ADDENDUM #02

PROJECT: **RENOVATIONS TO PALMERTON WEIGHT ROOM**
ISSUE DATE: Tuesday, March 5th 2024

RENOVATIONS TO PALMERTON HIGH SCHOOL WEIGHT ROOM

A0.01

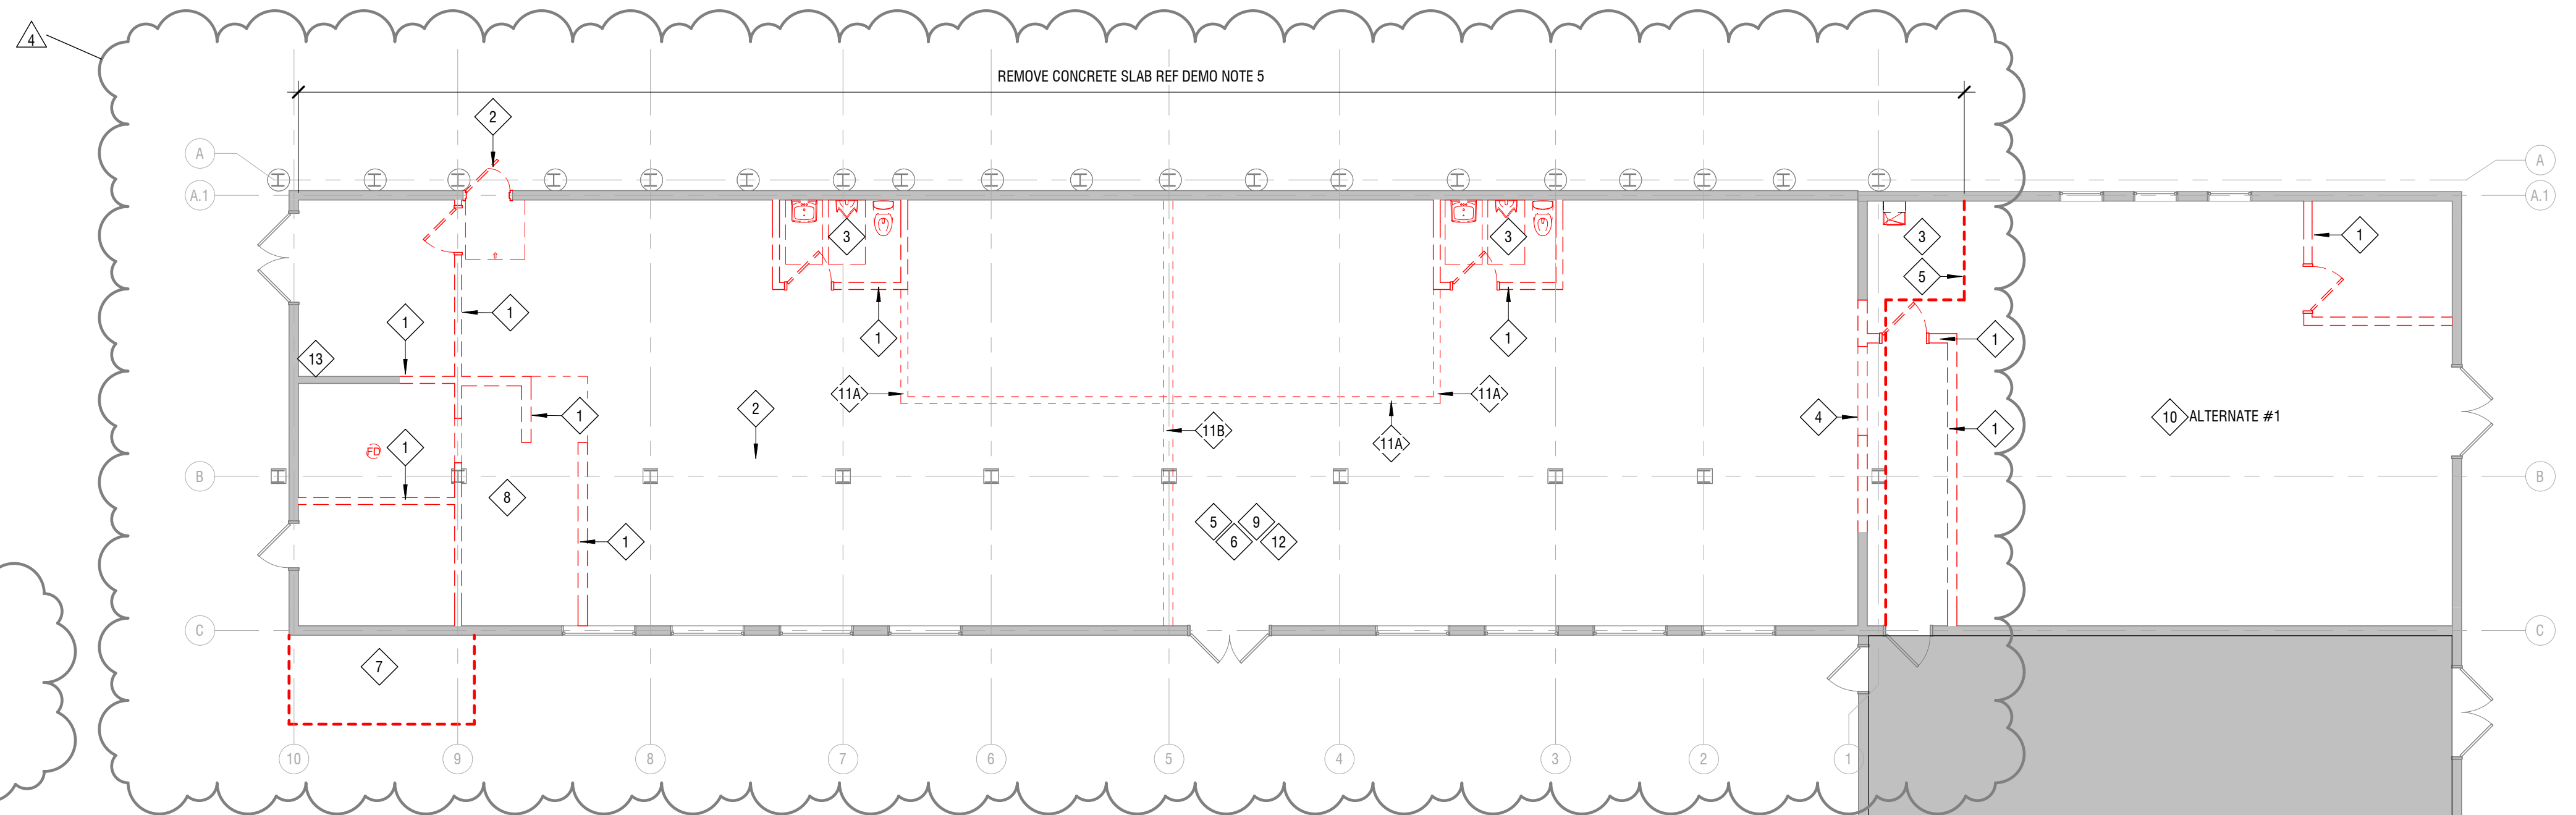
A0.01 – DEMOLITION PLAN – LEVEL 01

- Updated concrete slab information.
- Updated coordination notes.

COORDINATION OF DEMOLITION:

- WHERE FLOOR MOUNTED PLUMBING FIXTURES, FLOOR DRAINS, OR FLOOR PIPING ARE TO BE REMOVED, GC SHALL OPEN FLOOR. PLUMBING CONTRACTOR WILL BE RESPONSIBLE TO REMOVE ANY ADDITIONAL CONCRETE TO REACH PLUMBING NEEDED BELOW FLOOR AND THE GC WILL PATCH CONCRETE FLOOR AND FINISH AS PER SPECIFICATIONS. REFER TO MEP DRAWINGS.

11B	GC TO REMOVE EXISTING 8" FOOTER WALL IN SLAB AS INDICATED ON PLAN. GC TO VERIFY EXISTING LOCATIONS IN FIELD. GC TO ASSUME 4" OF STONE AND 4" NEW CONCRETE SLAB WITH LEVEL FINISH. REFER TO STRUCTURAL DRAWINGS FOR ADDITIONAL DETAILS.
12	GC TO CUT AND REMOVE THE ENTIRETY OF THE CONCRETE SLAB WITHIN A 1'-0" PERIMETER OF THE EXTERIOR WALLS AS INDICATED ON THE PLAN. GC TO ASSUME EXISTING SLAB IS 6". INFILL ACCORDINGLY FOR 2" OF STONE AND 4" NEW CONCRETE SLAB AND LEVEL FINISH. REFER TO STRUCTURAL DRAWINGS FOR ADDITIONAL DETAILS.
13	PLUMBING CONTRACTOR TO REMOVE EXISTING WATER HEATER AND ITS COMPONENTS IN ENTIRETY AND PREP FOR NEW INSTALLATION OF WATER HEATER. REFER TO PLUMBING DRAWINGS.

A4.00

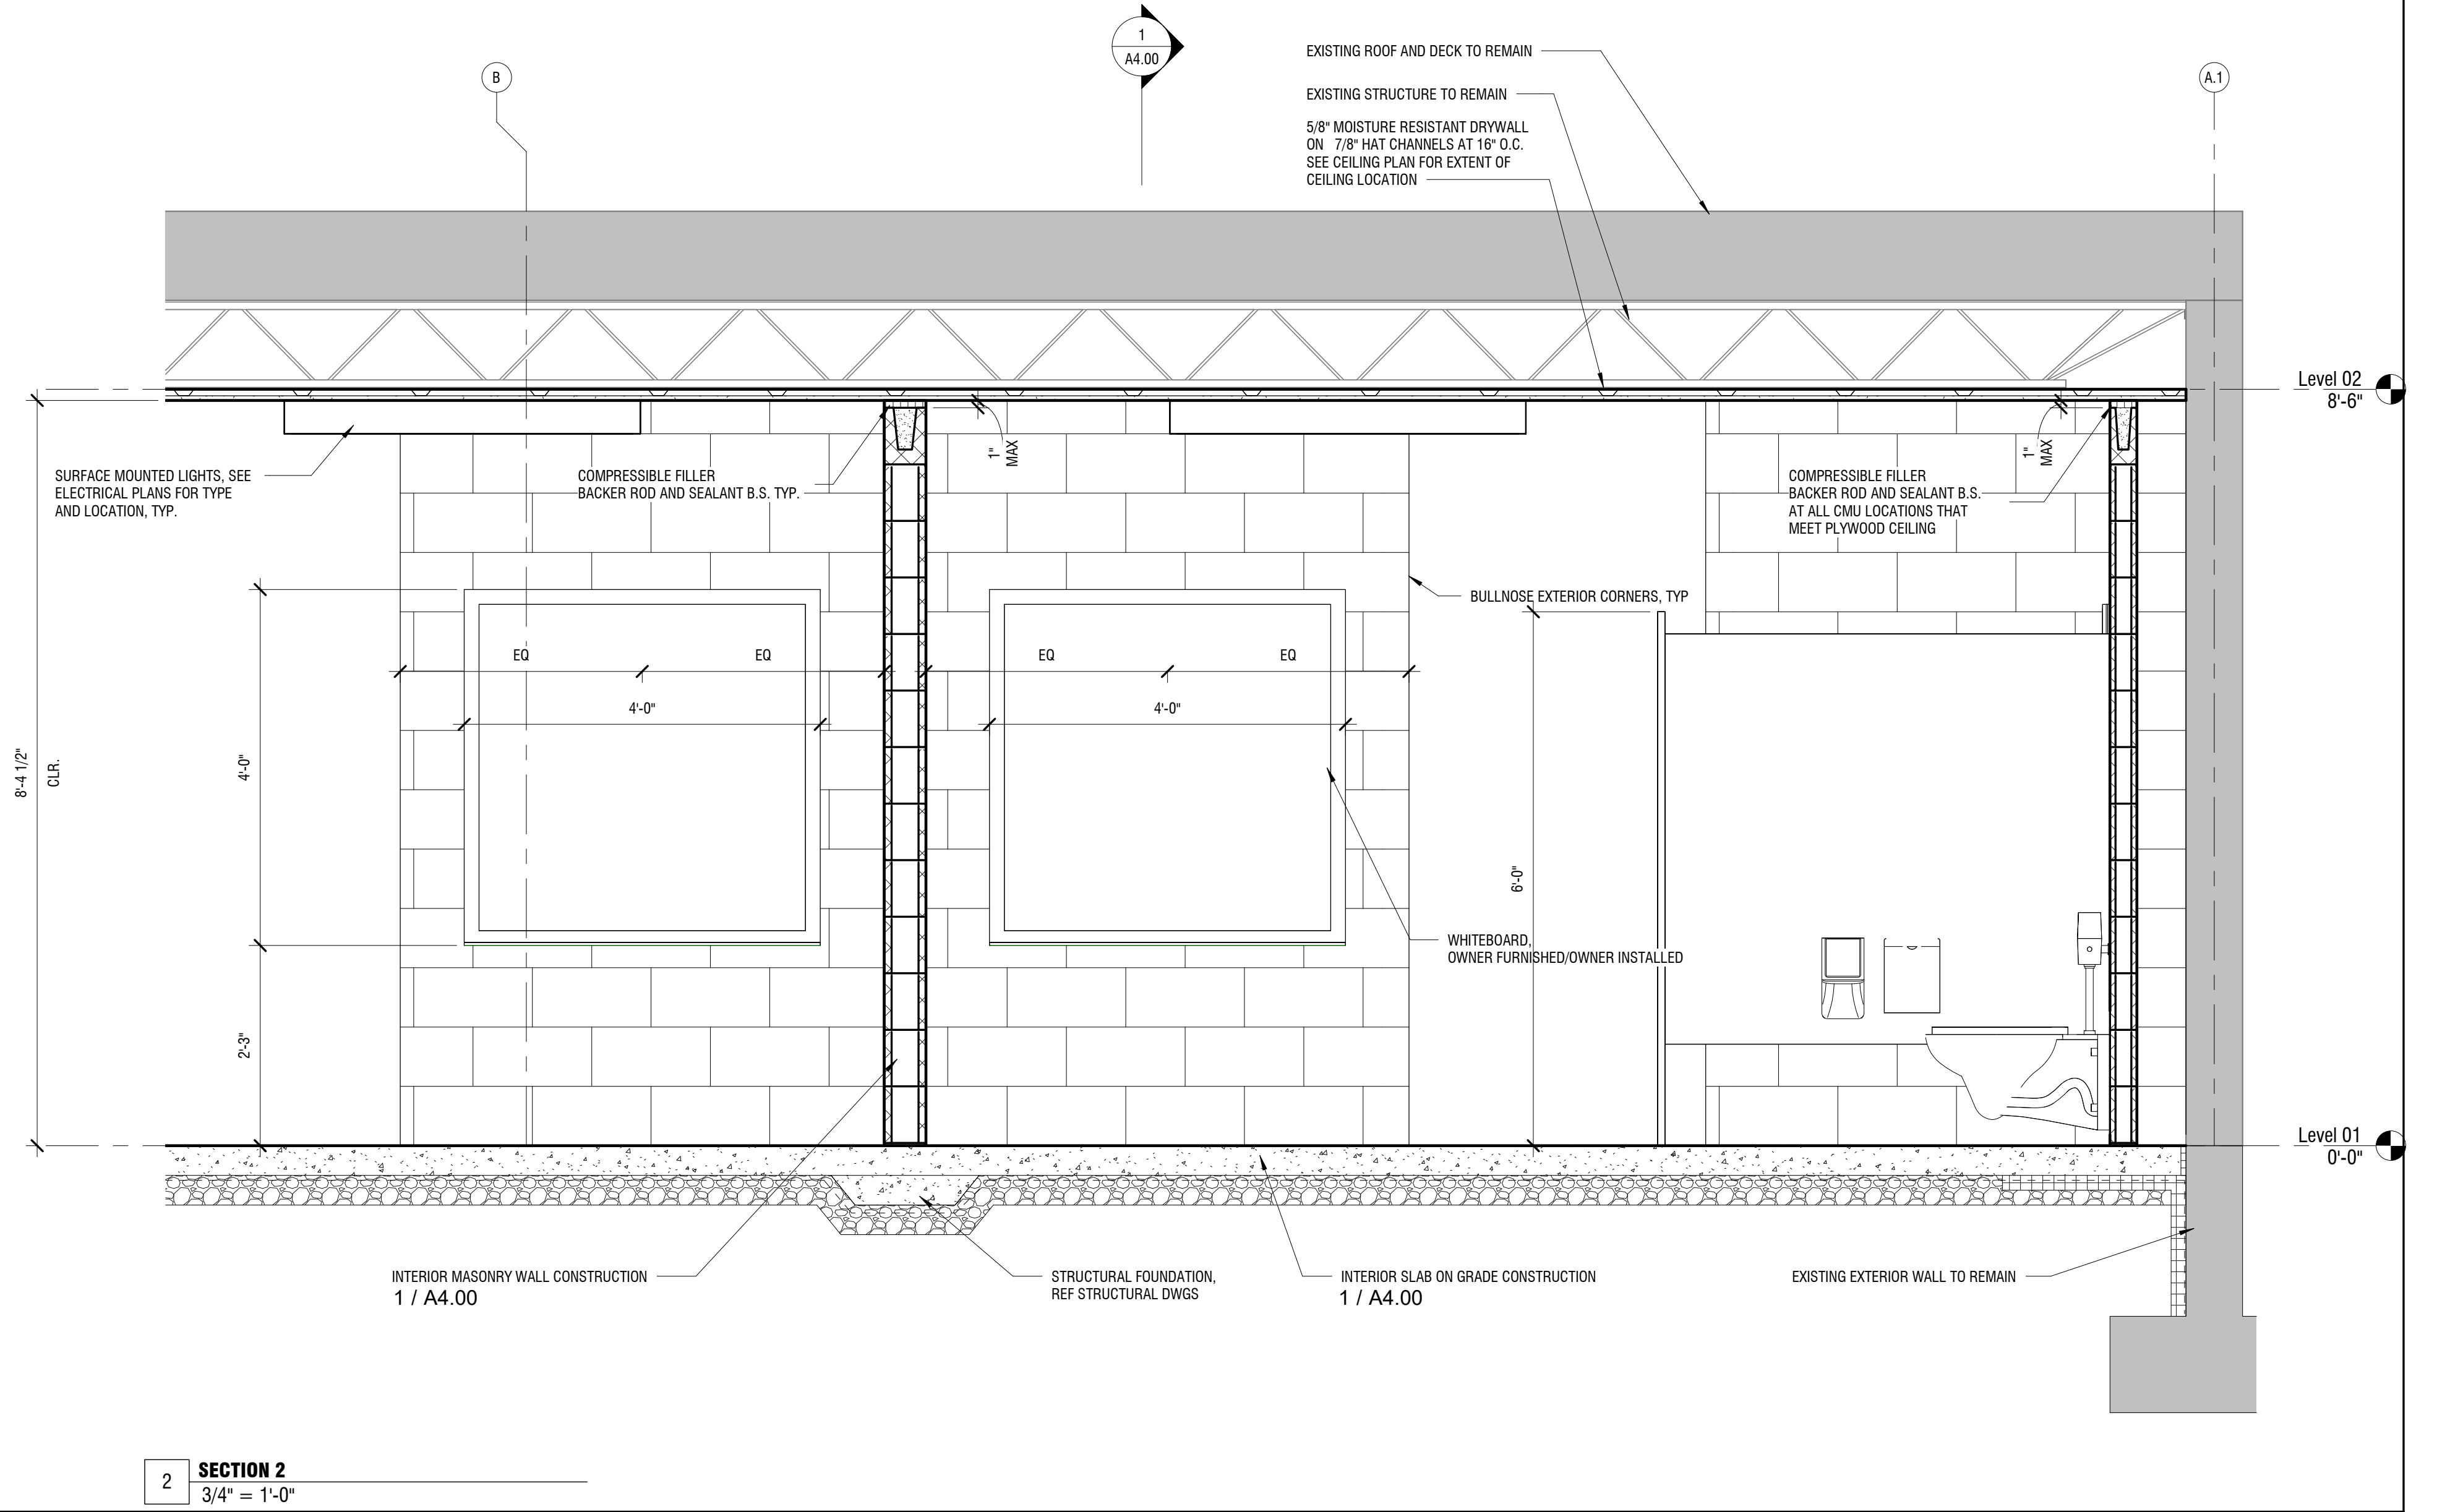
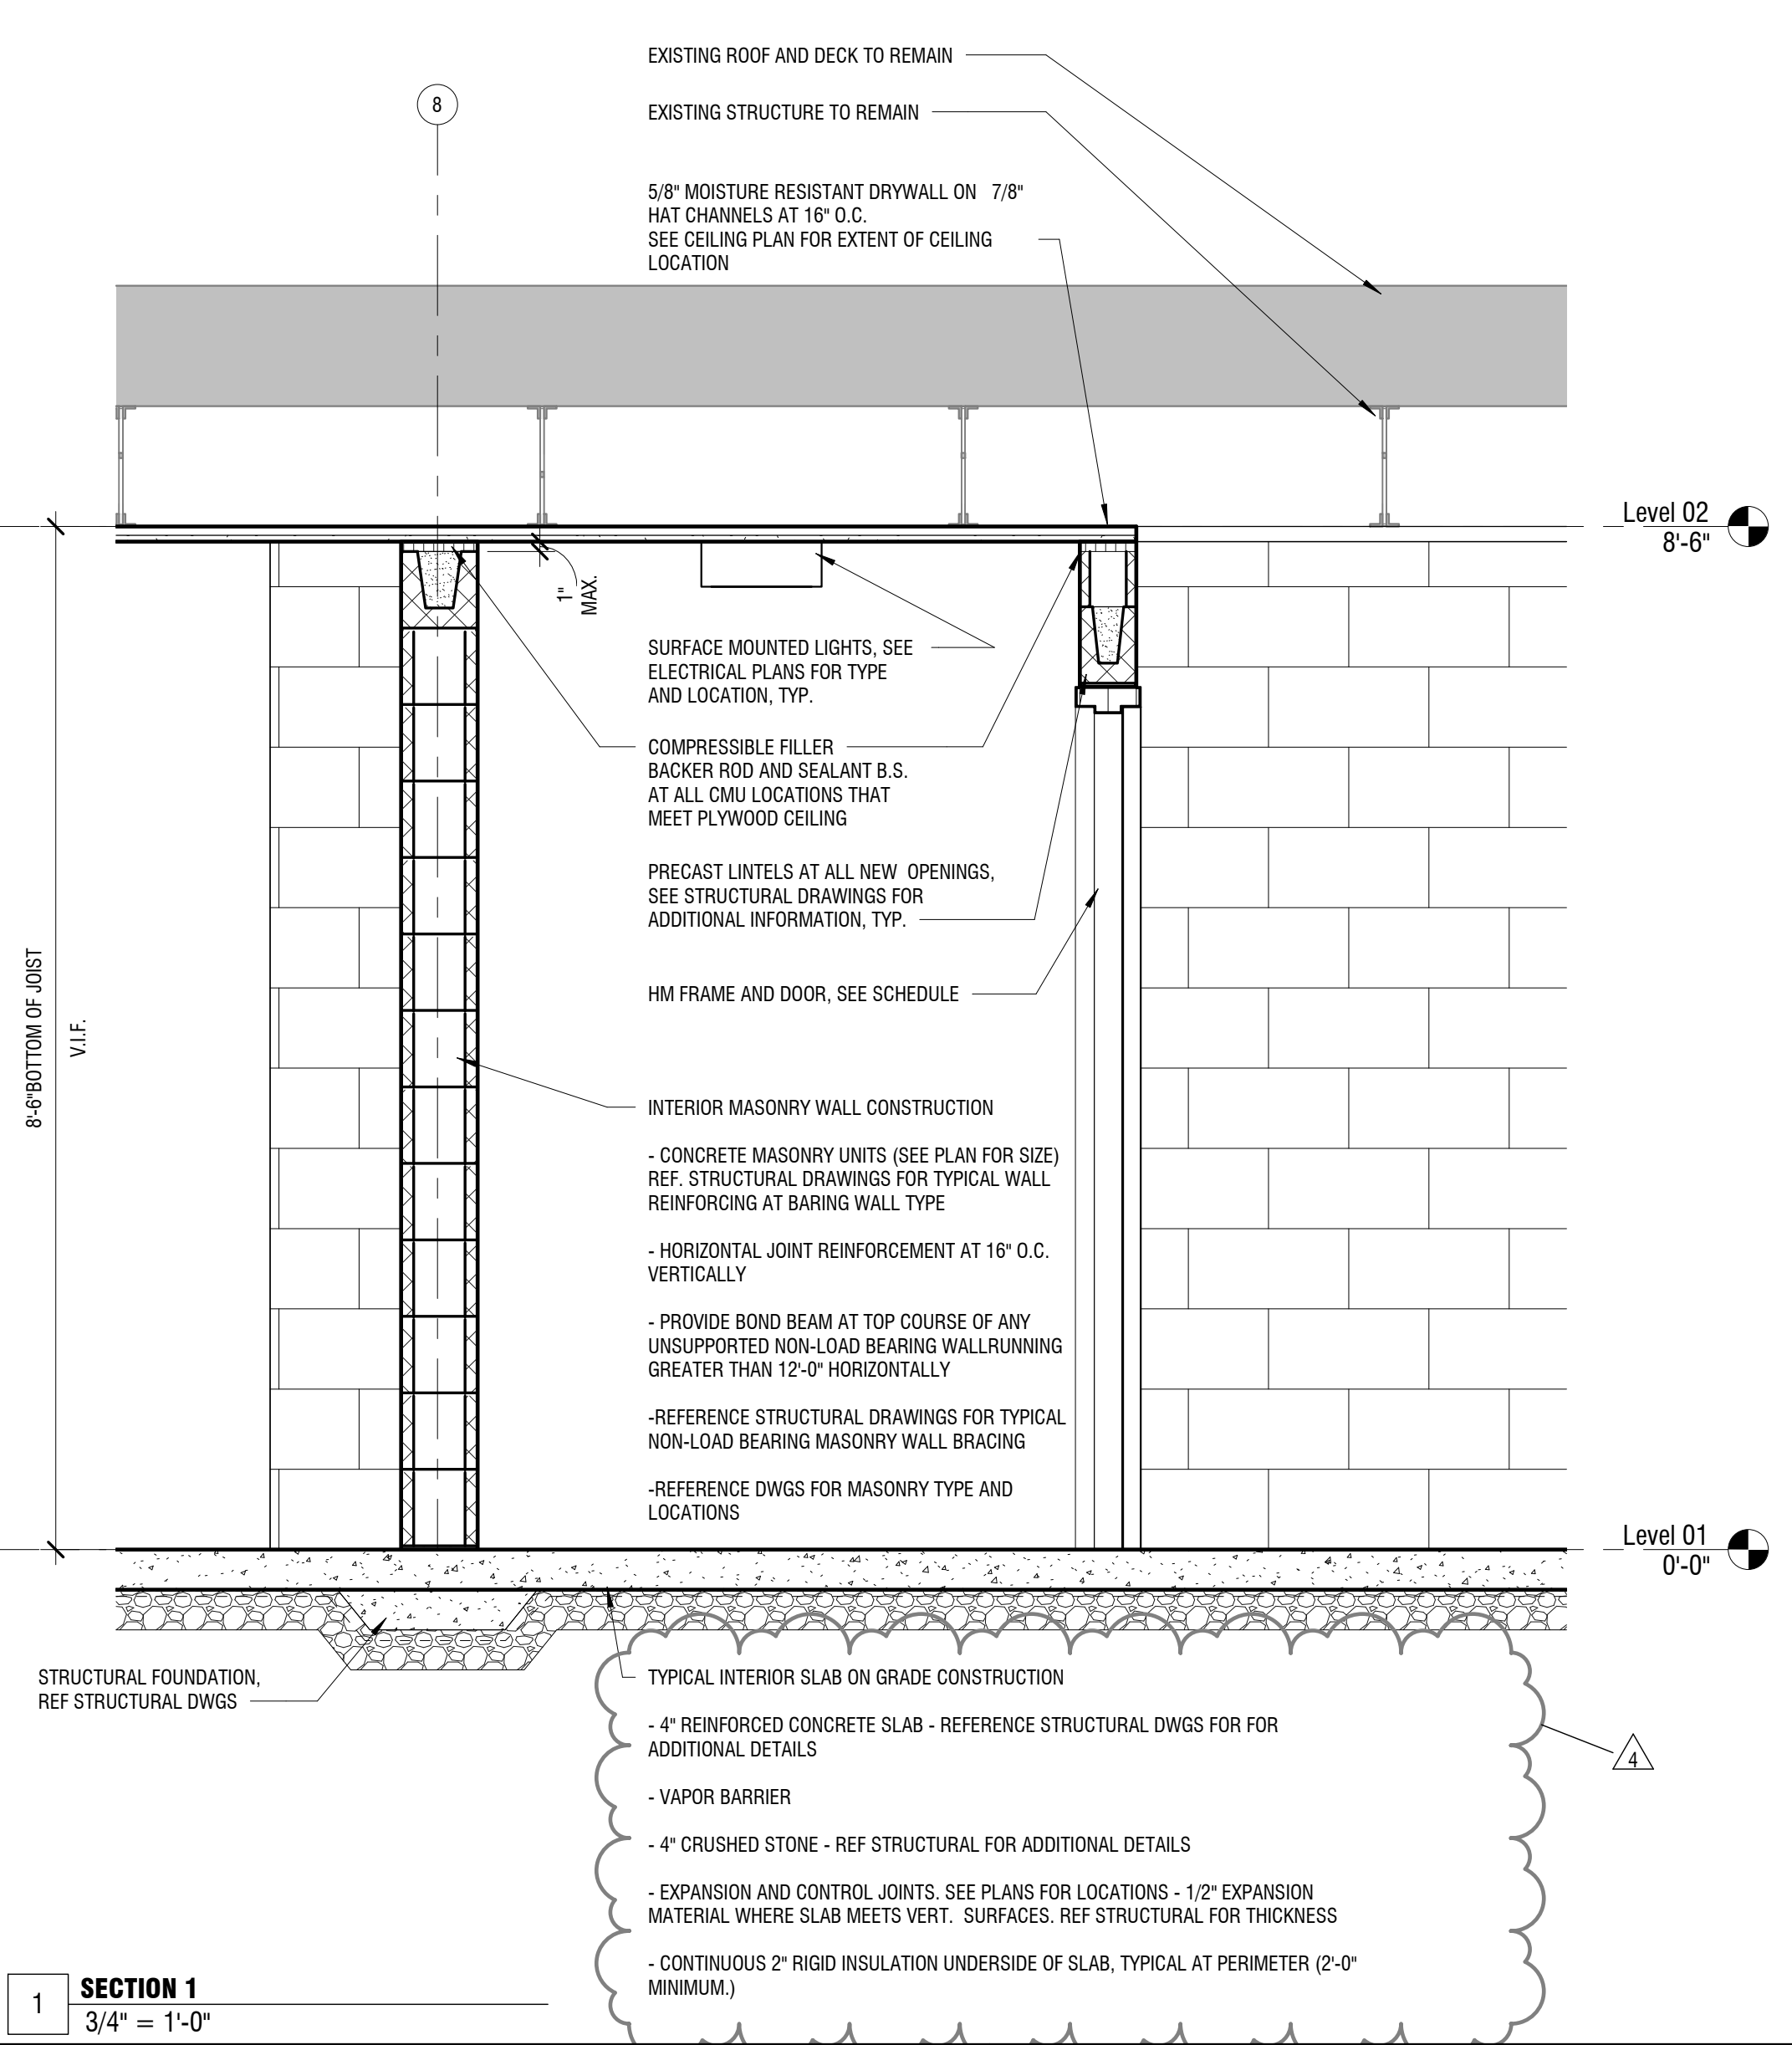
A4.00 – WALL SECTIONS

- Updated concrete slab information.
